Oakland City Planning Commission

STAFF REPORT

Case File Number PLN15-378; ER15-004

Project Name and Location:	Oak Knoll Mixed Use Community Plan Project , located on the former Oak Knoll Naval Medical Center Property at 8750 Mountain Boulevard, bounded by Keller Avenue and Mountain Boulevard. APNs: 043A-4675-003-21, 043A-4712-001 (portion), 043A-4675-003-19, 043A-4675-003-16, 043A4678-003-17 {roadway easement), 043A-4675-003- 30 (roadway easement) 048-6865-002-01, and 043A-4675-74-01.
Proposal:	Master Planned community on approximately 188 acres consisting of 935 residences, 72,000 square feet of neighborhood commercial, 14,000 square feet of civic use (relocated historic Club Knoll building as a community center), open space, creek restoration and trails.
Applicant/Owner:	Oak Knoll Venture Acquisitions LLC, c/o Suncal, Sam Veltri (949) 777-4000
Planning Permits Required:	Rezoning, Planned Unit Development permit (Preliminary and Final Development Plans), Tentative Tract Map, and other permits and/or approvals

Retail Center Scale Comparison Study

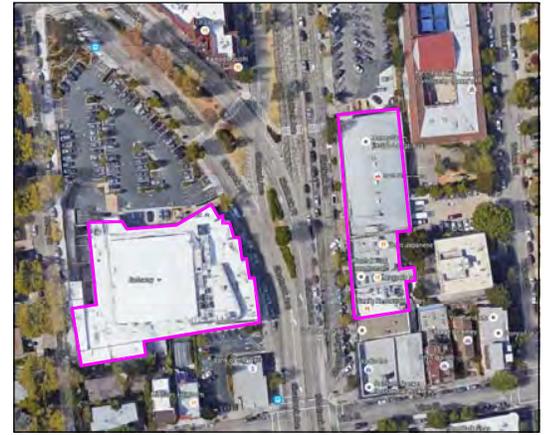
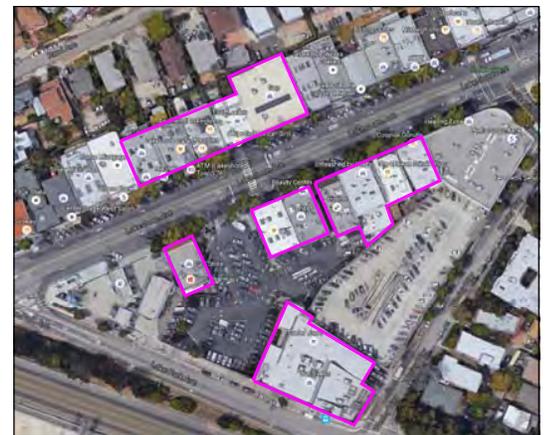
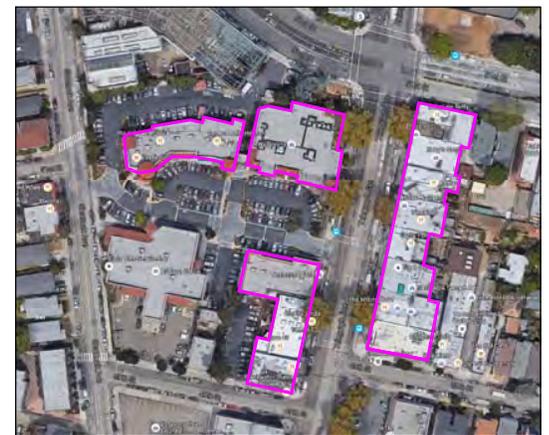
10. *DRC requests a scale comparison of other retail centers (e.g., Montclair, other small retail centers) to better understand scale of Village Center*

With regards to scale and layout, the size is significantly smaller than the retail district in the commercial core of Montclair, which has over 200k sf of retail/commercial.

It is similar in scale to the Trader Joes on Lakeshore, the Walgreens on 51st and Telegraph, or the Safeway on Shattuck and Vine St if you also count some of the in-line shops on the other side of the street. Please see attached exhibit showing these examples.
